OTTERPOOL PARK

Response to National Highways

FEBRUARY 2023

Final Stage 1 Road Safety Audit

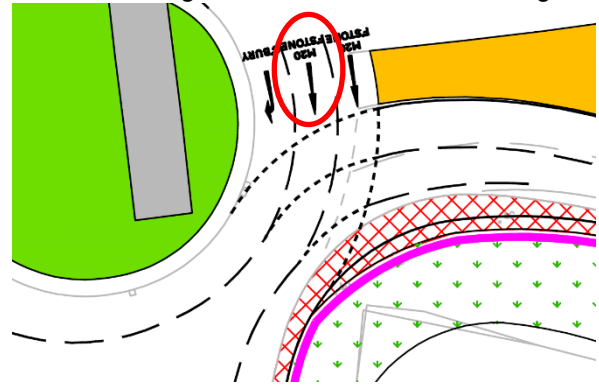
Location: General – A260 Spitfire Way Roundabout Junction (Drawing No. 10029956 OP ARC XX DR T 0018 Rev P01).

Summary: Unconventional roundabout lane markings may lead to poor lane discipline, indecision and result in sideswipe or driver / rider collisions.

Traffic management proposals to increase circulatory lanes, from a consistent wide carriageway to an unconventional two/three lane arrangement, is facilitated through a combination of contrasting spiral and concentric markings. There is a risk that this arrangement in combination with (i) the absence of suitable signage and (ii) inappropriate carriageway / destination markings may result in poor lane discipline, indecision and lead to sideswipe and driver / rider collisions. It is noted by way of example that the circulatory lane carriageway markings indicating 'M20' & 'F'stone' for the middle lane appears misleading as motorists are also permitted to access A260 Canterbury Road and A260 Spitfire Way (see insert).

Ensure that the roundabout layout is simple, uncomplicated and consistent with the proposed approach lanes. Ensure also that carriageway markings are unconfusing and supplemented with suitable traffic signs to aid traffic management. In addition, the use of circulatory guidance markings (where lanes cross and merge) to show a path through a junction may help benefit carriageway marking transitions.

APPENDIX B – PROBLEM LOCATIONS

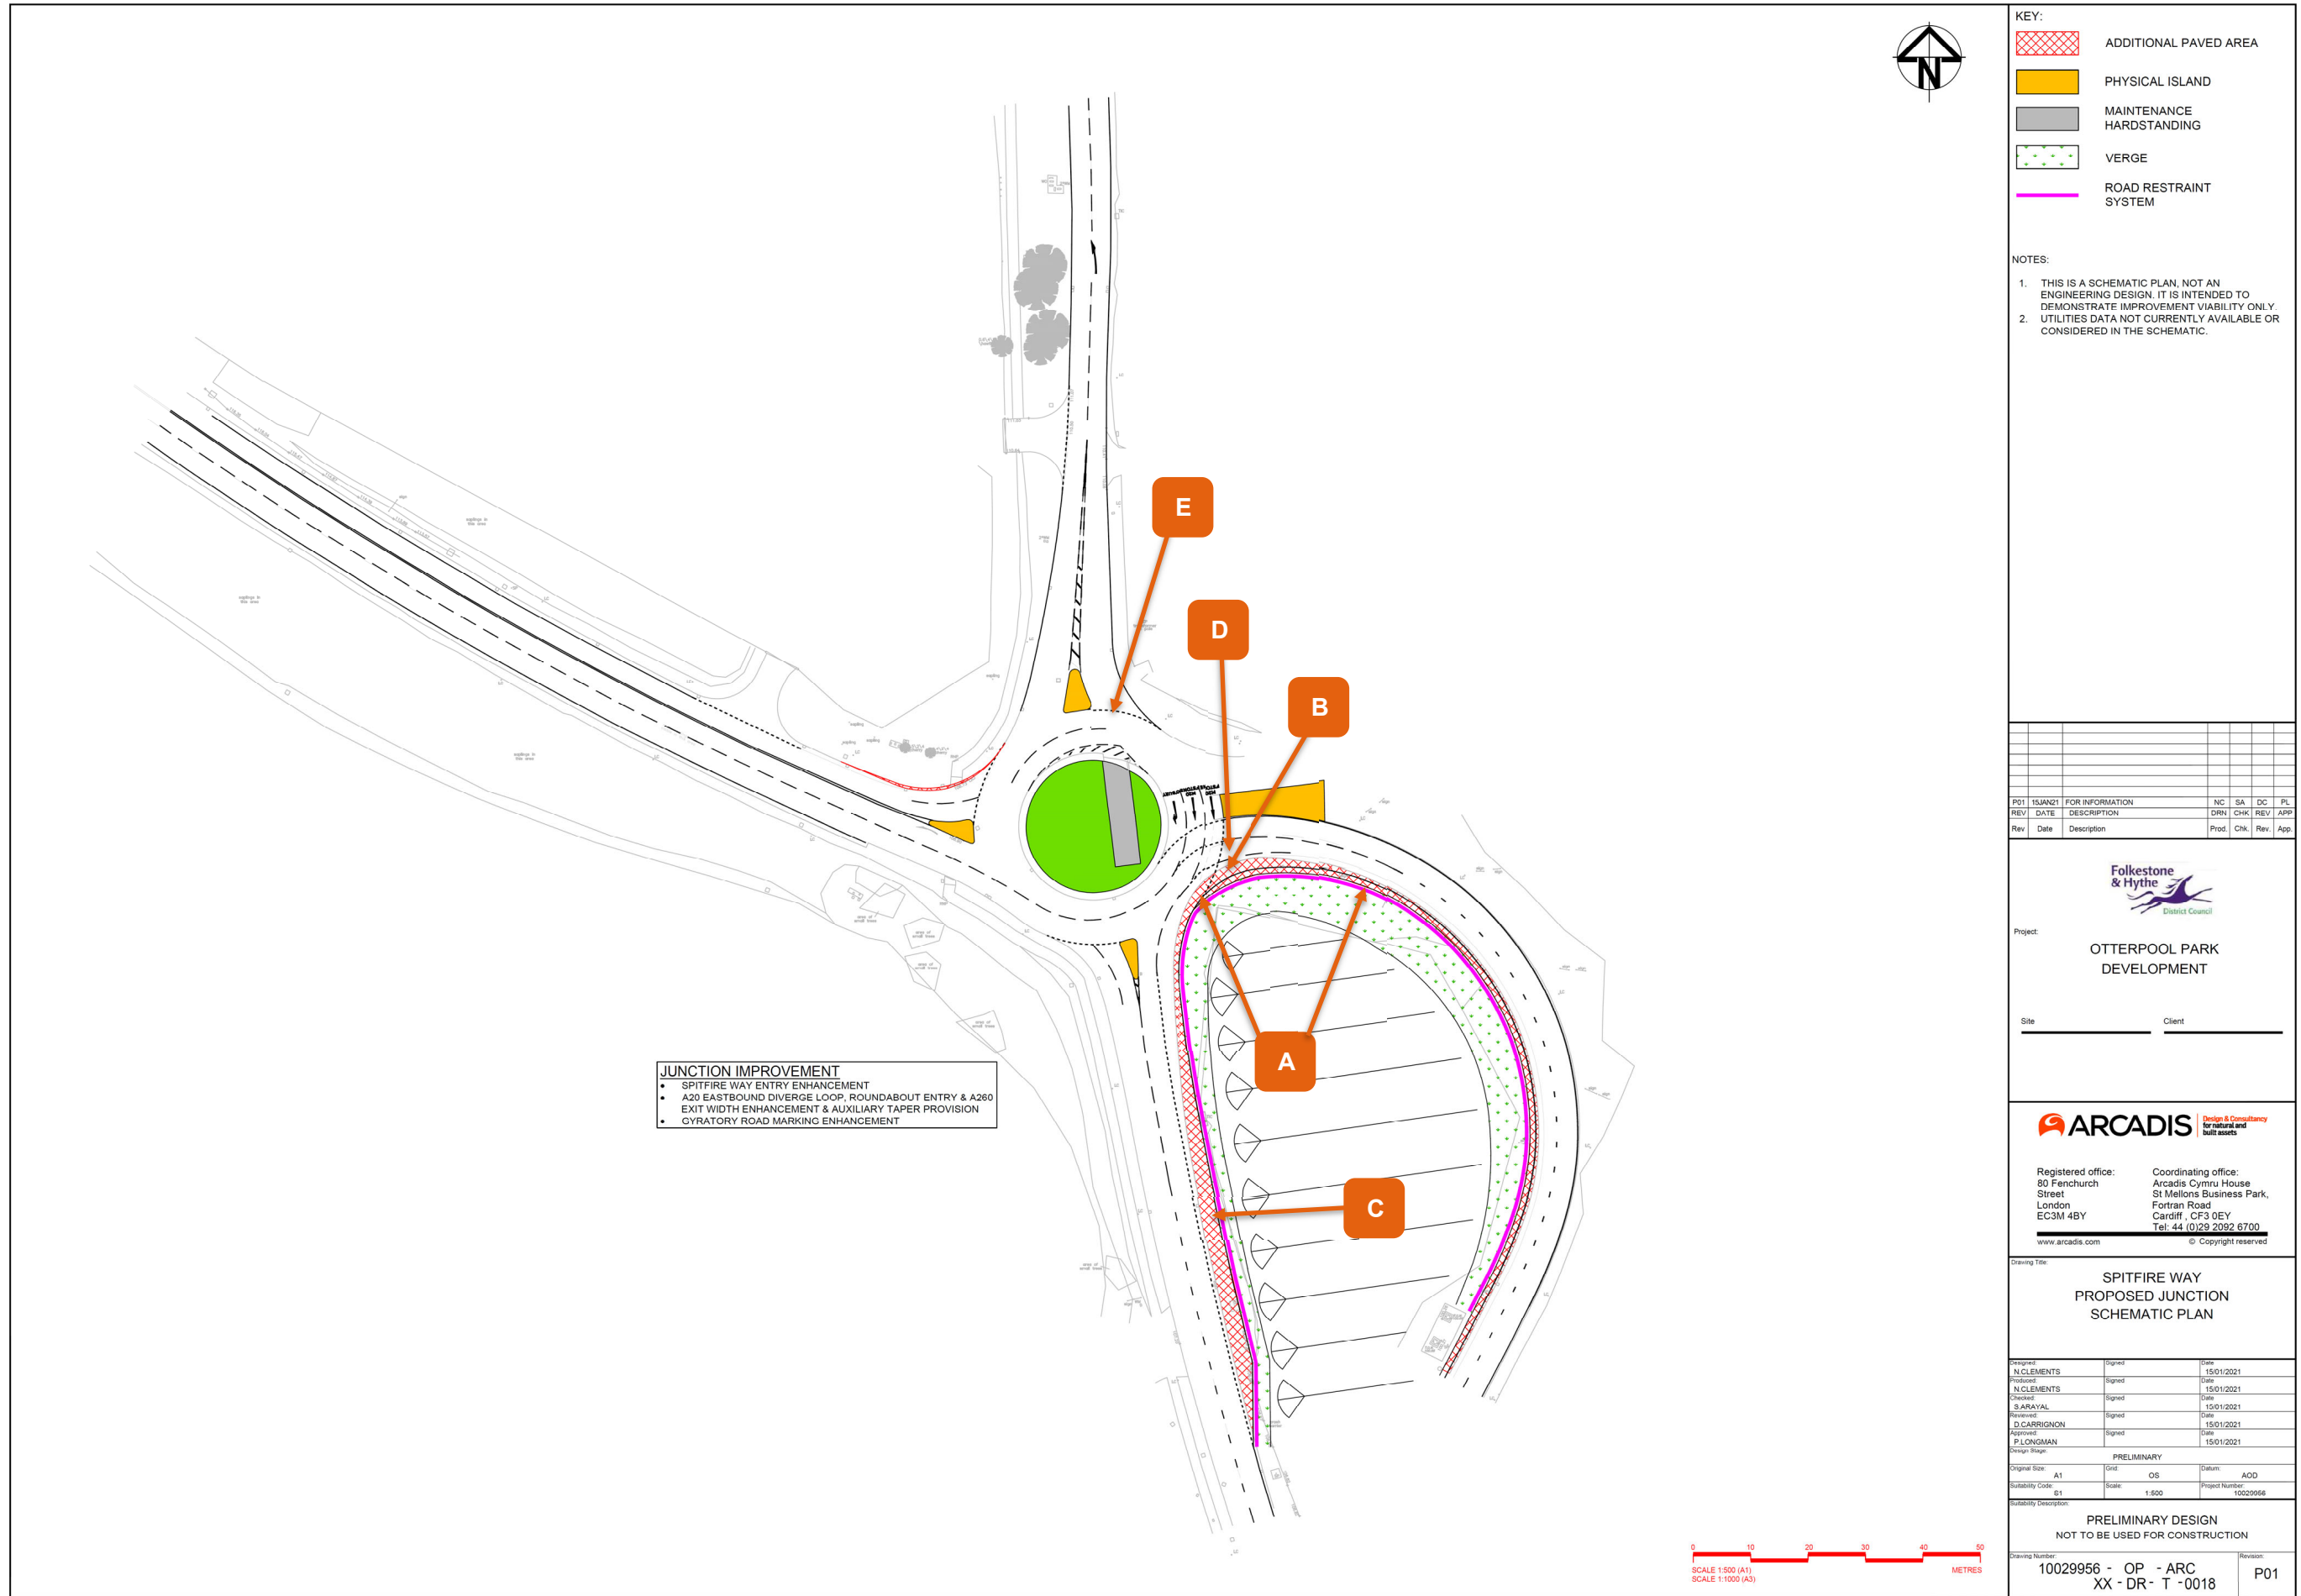
Location: A - A20 Northbound Offslip to A260 Spitfire Way Junction (Drawing No. 10029956 OP ARC XX DR T 0018 Rev P01).

Summary: Risk of motorists striking street furniture or errant vehicles leaving the carriageway resulting in secondary collisions.

It is proposed to widen the nearside carriageway of the A20 northbound offslip to A260 Spitfire Way Junction from one lane to two lanes (along the offslip carriageway) and then from two lanes to three lanes at A260 Spitfire Way junction. The proposed widening appears to encroach close to, or onto, the nearside verge where traffic signs, lighting and other highway features reside (see photos 1&2).

There is a risk that existing highway furniture located close to the carriageway may be struck by oncoming motorists, or that errant vehicles may leave the carriageway and strike the highway features resulting in a secondary collision.

Location: A – A20 Northbound Offslip to A260 Spitfire Way Junction (Drawing No. 10029956 OP ARC XX DR T 0018 Rev P01).

Summary: Restricted forward visibility approaching the junction may lead to late braking and shunt collisions.

It is proposed to widen the A20 Offslip into and through the A260 Spitfire Way Junction by utilizing the nearside verge accordingly. The vegetation on the verge is overgrown and in its current form likely to impact on forward visibility (see photo).

There is a risk that motorists forward visibility approaching the junction may be restricted, particularly during summer months. This may result in late braking and shunt collisions.

Location: A – A20 Northbound Offslip to A260 Spitfire Way Junction (Drg. 10029956-OP-ARC-XX-DR-T-0018 Rev P01).

Summary: Risk of ponding leading to motorists suffering loss of control type collisions.

There is a risk that carriageway widening proposed to facilitate additional capacity along the A20 northbound offslip may lead to ponding of surface water and skidding / loss of control collisions, particularly during wet weather or icy conditions. Although existing drainage gullies were observed along the nearside kerblines and on the approach to the A260 Spitfire Way roundabout junction they do not appear to be relocated as part of the widening works.

Location: A – A20 Northbound Offslip to A260 Spitfire Way Junction (Drg. 10029956-OP-ARC-XX-DR-T-0018 Rev P01).

Summary: Retention of existing gullies may hinder power-two-wheelers leading to wet road collisions.

Existing drainage gullies were observed along the nearside kerblines of the A20 Northbound Offslip carriageway and on the approach to the A260 Spitfire Way roundabout junction. Where the carriageway widening is proposed this is likely to require relocating the current system of drainage. However, if drainage is retained in the current location, the gullies may pose a skidding risk and unseat riders of powered-two-wheelers using the nearside lane. This situation is likely to be worse due to the horizontal alignment of the carriageway, and particularly during wet weather conditions.

Location: B – A20 Northbound Offslip to A260 Spitfire Way Junction (Drg. 10029956-OP-ARC-XX-DR-T-0018 Rev P01).

Summary: Risk of loss of control collisions.

The A20 Offslip currently has high friction surfacing albeit in a poor state of repair. It is unclear at this stage whether this is to be replaced and incorporated into the extra lane proposed. There is a risk that if the additional lane does not incorporate high friction surfacing this may lead to skidding or loss of control collisions particularly during wet weather periods.

Location: C – A260 White Horse Hill Southbound Carriageway South of A260 Spitfire Way Roundabout (Drg. 10029956-OP-ARC-XX-DR-T-0018 Rev P01).

Summary: Risk of merge arrangement leading to late-braking or side-swipe type collisions.

Those travelling southbound along the nearside lane of A260 White Horse Hill will be required to merge into the adjacent lane some distance from the roundabout. If motorists are not aware of the merging arrangement this may lead to late-braking or side-swipe collisions.

Location: D – A20 Northbound Offslip / A260 Spitfire Way Junction (Drawing No. 10029956 OP ARC XX DR T 0018 Rev P01).

Summary: Additional approach lanes and circulatory lanes may lead to confusion, indecision, or shunt collisions.

Providing an additional lane on the approach to and through A260 Spitfire Way Junction is likely to result in motorists in the middle lane experiencing difficulties observing traffic signs, particularly if flanked by high-sided vehicles. This may lead to confusion, indecision, or shunt collisions.

Location: E – White Horse Hill Northern Arm Southbound Approach to the Roundabout (Drg. 10029956-OP-ARC-XX-DR-T-0018 Rev P01).

Summary: Risk of poor lane discipline resulting in side-swipe and late braking collisions.

The southbound approach to the A260 Spitfire Way Junction from White Horse Hill currently accommodated two approach lanes. However, this approach lane arrangement does not appear to be continued as part of the proposed works. There is a risk that the proposed wide approach lane may lead to poor lane discipline and result in side-swipe and late braking collisions. Powered-two-wheelers and pedal cyclists are likely to be particularly at greater risk.

Ensure that all street furniture along the adjacent verge is either suitably relocated, protected by road restraint, or made passively safe. Furthermore, the use of kerbing alongside the verge may also help contain errant vehicles leaving the carriageway.

Ensure forward visibility to the junction is sufficient to allow approaching motorists to observe the operation of the junction, queuing vehicles or obstructions in the carriageway ahead. This may require vegetation to be cut back and regularly maintained.

It is recommended that suitable drainage is provided along the carriageway kerblines.

Ensure that where local carriageway widening occurs drainage gullies are relocated along the new kerblines.

It is recommended that the A20 Offslip is treated with a high friction surfacing for a suitable distance from the give-way lines.

It is recommended that suitable warning of the merge through signing and carriageway markings is provided, and that the end of the merge promotes a gradual transition.

It is recommended that suitable lane destination traffic signs and carriageway markings are provided to support traffic management on the approach to and through the junction. The use of 'approach' and 'entry' carriageway markings may also help to promote good traffic management.

Ensure that the approach lane arrangement promotes good lane discipline.

RSA problem	RSA recommendation	Design Organisation response	Overseeing Organisation response	Agreed RSA action
<p>Problem 3.1.1</p> <p>Location: A - A20 Northbound Offslip to A260 Spitfire Way Junction (Drawing No. 10029956 OP ARC XX DR T 0018 Rev P01).</p> <p>Summary: Risk of motorists striking street furniture or errant vehicles leaving the carriageway resulting in secondary collisions.</p> <p>It is proposed to widen the nearside carriageway of the A20 northbound offslip to A260 Spitfire Way Junction from one lane to two lanes (along the offslip carriageway) and then from two lanes to three lanes at A260 Spitfire Way junction. The proposed widening appears to encroach close to, or onto, the nearside verge where traffic signs, lighting and other highway features reside.</p> <p>There is a risk that existing highway furniture located close to the carriageway may be struck by oncoming motorists, or that errant vehicles may leave the carriageway and strike the highway features resulting in a secondary collision.</p> <p>A similar situation occurs along the proposed southbound merge arrangement associated with A260 White Horse Hill.</p>	<p>Ensure that all street furniture along the adjacent verge is either suitably relocated, protected by road restraint, or made passively safe. Furthermore, the use of kerbing alongside the verge may also help contain errant vehicles leaving the carriageway.</p>	<p>Agree</p> <p>All highway furniture on the verge and elsewhere will be subject to RRRAP and detailed to suit. Kerbing provisions will be driven by safety (including drainage) considerations.</p>

<p>Problem 3.1.2</p> <p>Location: A – A20 Northbound Offslip to A260 Spitfire Way Junction (Drawing No. 10029956 OP ARC XX DR T 0018 Rev P01).</p> <p>Summary: Restricted forward visibility approaching the junction may lead to late braking and shunt collisions.</p>	<p>Ensure forward visibility to the junction is sufficient to allow approaching motorists to observe the operation of the junction, queuing vehicles or obstructions in the carriageway ahead. This may require</p>	<p>Agree</p> <p>Drawing indicates widening of verge to provide visibility to the junction.</p>

RSA problem	RSA recommendation	Design Organisation response	Overseeing Organisation response	Agreed RSA action
<p>It is proposed to widen the A20 Offslip into and through the A260 Spitfire Way Junction by utilizing the nearside verge accordingly. The vegetation on the verge is overgrown and in its current form likely to impact on forward visibility (see photo).</p> <p>There is a risk that motorists forward visibility approaching the junction may be restricted, particularly during summer months. This may result in late braking and shunt collisions.</p>	<p>vegetation to be cut back and regularly maintained.</p>			
<p>Problem 3.1.3</p> <p>Location: A – A20 Northbound Offslip to A260 Spitfire Way Junction (Drg. 10029956-OP-ARC-XX-DR-T-0018 Rev P01).</p> <p>Summary: Risk of ponding leading to motorists suffering loss of control type collisions.</p> <p>There is a risk that carriageway widening proposed to facilitate additional capacity along the A20 northbound offslip may lead to ponding of surface water and skidding / loss of control collisions, particularly during wet weather or icy conditions. Although existing drainage gullies were observed along the nearside kerblines and on the approach to the A260 Spitfire Way roundabout junction they do not appear to be relocated as part of the widening works.</p> <p>A similar situation occurs along the southeastern quadrant of the roundabout nearside circulatory carriageway, A260 southbound nearside carriageway and nearside eastbound carriageway of Spitfire Lane, where in all cases local widening measures are also proposed.</p>	<p>It is recommended that suitable drainage is provided along the carriageway kerblines.</p>	<p>Agree</p> <p>A safe drainage design will be implemented at detail design stage.</p>

<p>Problem 3.1.4</p> <p>Location: A – A20 Northbound Offslip to A260 Spitfire Way Junction (Drg. 10029956-OP-ARC-XX-DR-T-0018 Rev P01).</p> <p>Summary: Retention of existing gullies may hinder power-two-wheelers leading to wet road collisions.</p> <p>Existing drainage gullies were observed along the nearside kerblines of the A20 Northbound Offslip carriageway and on the approach to the A260</p>	<p>Ensure that where local carriageway widening occurs drainage gullies are relocated along the new kerblines.</p>	<p>Agree</p> <p>A safe drainage design will be implemented at detail design stage.</p>

RSA problem	RSA recommendation	Design Organisation response	Overseeing Organisation response	Agreed RSA action
<p>Spitfire Way roundabout junction. Where the carriageway widening is proposed this is likely to require relocating the current system of drainage. However, if drainage is retained in the current location, the gullies may pose a skidding risk and unseat riders of powered-two-wheelers using the nearside lane. This situation is likely to be worse due to the horizontal alignment of the carriageway, and particularly during wet weather conditions.</p> <p>A similar situation occurs along the A260 White Horse Hill southern arm southbound nearside carriageway.</p>				
<p>Problem 3.1.5</p> <p>Location: B – A20 Northbound Offslip to A260 Spitfire Way Junction (Drg. 10029956-OP-ARC-XX-DR-T-0018 Rev P01).</p> <p>Summary: Risk of loss of control collisions.</p> <p>The A20 Offslip currently has high friction surfacing albeit in a poor state of repair. It is unclear at this stage whether this is to be replaced and incorporated into the extra lane proposed. There is a risk that if the additional lane does not incorporate high friction surfacing this may lead to skidding or loss of control collisions particularly during wet weather periods.</p>	<p>It is recommended that the A20 Offslip is treated with a high friction surfacing for a suitable distance from the give-way lines.</p>	<p>Agree</p> <p>At detailed design, appropriate DMRB compliant road surfacing will be installed throughout.</p>

RSA problem	RSA recommendation	Design Organisation response	Overseeing Organisation response	Agreed RSA action
<p>Similarly, there is a risk that this layout could increase the risk of some motorists carrying out nearside overtaking manoeuvres to past slower moving vehicles.</p> <p>The Audit Team note that the merge facility also terminates rather abruptly.</p> <p>.</p>				
<p>Problem 3.2.1</p> <p>Location: D – A20 Northbound Offslip / A260 Spitfire Way Junction (Drawing No. 10029956 OP ARC XX DR T 0018 Rev P01).</p> <p>Summary: Additional approach lanes and circulatory lanes may lead to confusion, indecision, or shunt collisions.</p> <p>Providing an additional lane on the approach to and through A260 Spitfire Way Junction is likely to result in motorists in the middle lane experiencing difficulties observing traffic signs, particularly if flanked by high-sided vehicles. This may lead to confusion, indecision, or shunt collisions.</p>	<p>It is recommended that suitable lane destination traffic signs and carriageway markings are provided to support traffic management on the approach to and through the junction. The use of 'approach' and 'entry' carriageway markings may also help to promote good traffic management.</p>	<p>Agree</p> <p>Appropriate traffic sign and road marking provisions will be implemented at detail design stage.</p>

RSA problem	RSA recommendation	Design Organisation response	Overseeing Organisation response	Agreed RSA action
<p>Problem 3.3.1</p> <p>Location: General – A260 Spitfire Way Roundabout Junction (Drawing No. 10029956 OP ARC XX DR T 0018 Rev P01).</p> <p>Summary: Unconventional roundabout lane markings may lead to poor lane discipline, indecision and result in sideswipe or driver / rider collisions.</p> <p>Traffic management proposals to increase circulatory lanes, from a consistent wide carriageway to an unconventional two/three lane arrangement, is facilitated through a combination of contrasting spiral and concentric markings. There is a risk that this arrangement in combination with (i) the absence of suitable signage and (ii) inappropriate carriageway / destination markings may result in poor lane discipline, indecision and lead to sideswipe and driver / rider collisions. It is noted by way of example that the circulatory lane carriageway markings indicating 'M20' & 'F'stone' for the middle lane appears misleading as motorists are also permitted to access A260 Canterbury Road and A260 Spitfire Way (see insert).</p> <p>The situation is likely to become worse as any roundabout congestion may limit opportunity for motorists to change lanes, observe carriageway markings or observe approaching traffic.</p> <p>The Audit Team notes that under the current junction arrangement the collision record is currently low.</p>	<p>Ensure that the roundabout layout is simple, uncomplicated and consistent with the proposed approach lanes. Ensure also that carriageway markings are unconfusing and supplemented with suitable traffic signs to aid traffic management. In addition, the use of circulatory guidance markings (where lanes cross and merge) to show a path through a junction may help benefit carriageway marking transitions.</p>	<p>Agree</p> <p>The current feasibility stage road markings and lane designation signs will be reviewed and further enhanced at detail design stage.</p> <p>All traffic signs and road marking details developed at future desing stage will be clear and not liable to be misconstrued.</p>
